Regulatory Correspondence

CIRNAC Inspection Reports and Baffinland Response

RE: Water Licence 2AM-MRY1325 January 2019 Inspection Report

RE: Water Licence 2AM-MRY1325 May 2019 Inspection Report

Photo 1

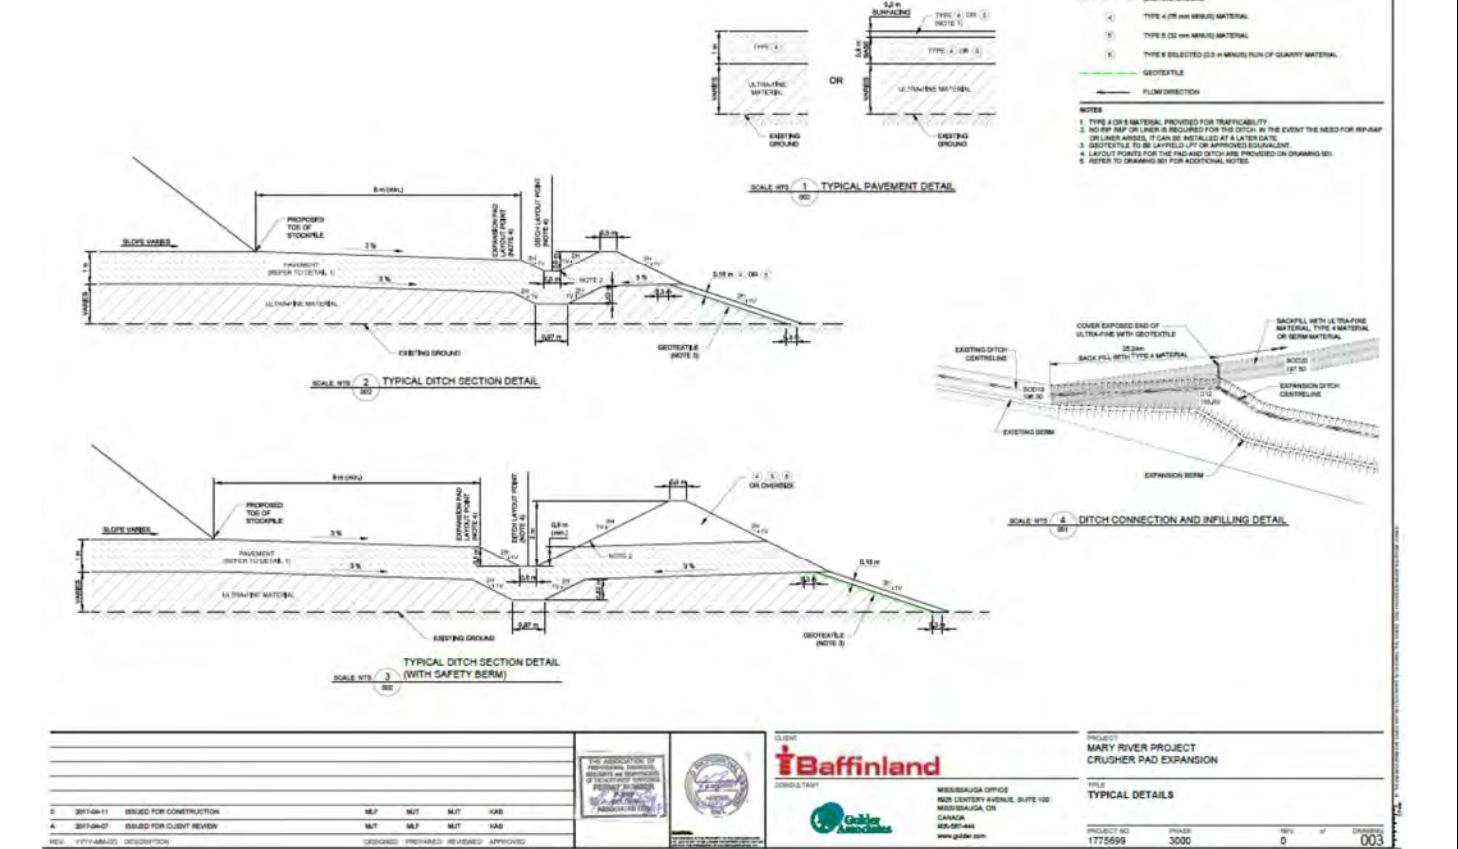
- c. As mentioned in previous inspection reports the slope of the ditches surrounding this facility do not appear to be consistent with the approved design and the construction material does not appear to be the approve size. (see Photo 1).

Description: Pooling in unlined ditches of the Crusher pad
